# Access Compliance Report

## Public Rights-of-Way

### (Curb Ramps)

Intersection ID: 4508	Main Street: NORCROFT_DR	Cross Street: W_W_T_HARRIS_BV	Location: W
ADA ID: 576540B5F1A8	Ramp Type: Perp	Initial Pass/Fail: Fail	Overall Compliance: No
Severity Score: 33.75			
Codes/Mitigation Info/Possible Solution		Field Measurements/Component Compliance

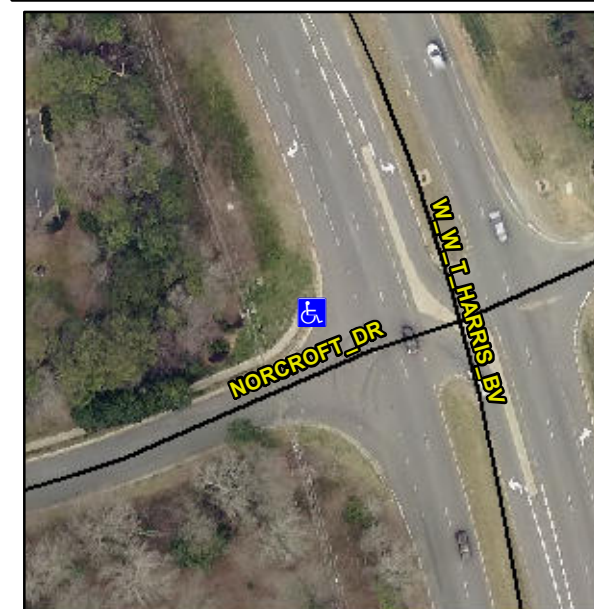
**Not Found, R304.5.1, R304.5.3**

Compliance	Description	Data	Compliance	Description	Data
N/A	Ramp Length (in)	49.5	Yes	Ramp Slope (%)	5.0
No	Ramp Width (in)	42.0	No	Ramp XSlope (%)	11.7
N/A	Flare Type LT	N/A	N/A	Flare Type RT	N/A
N/A	Flare Slope LT (%)	N/A	N/A	Flare Slope RT (%)	N/A
N/A	Flare Traversable LT?	N/A	N/A	Flare Traversable RT?	N/A
N/A	Landing Length (in)	N/A	N/A	DWS Provided?	N/A
N/A	Landing Width (in)	N/A	N/A	DWS Contrast?	N/A
N/A	Landing Slope (%)	N/A	N/A	DWS Length (in)	N/A
N/A	Landing X Slope (%)	N/A	N/A	DWS Full Width?	N/A
N/A	Landing Curb? (Y/N)	N/A	N/A	DWS Offset (in)	N/A
N/A	Shared Landing?	N/A			
N/A	Gutter Ponding?	N/A	N/A	Gutter Slope (%)	N/A
N/A	Gutter Lip Ht (in)	N/A	N/A	Gutter X Slope (%)	N/A
N/A	Painted X Walk1?	No	N/A	Painted X Walk2?	N/A
	X Walk 1 Direction	To E		X Walk 2 Direction	N/A
N/A	X Walk 1 Width (in)	N/A	N/A	X Walk 2 Width (in)	N/A
	X Walk 1 Slope (%)	2.8		X Walk 2 Slope (%)	N/A
	X Walk 1 X Slope (%)	11.8		X Walk 2 X Slope (%)	N/A

**Remove & Replace Entire Ramp.**
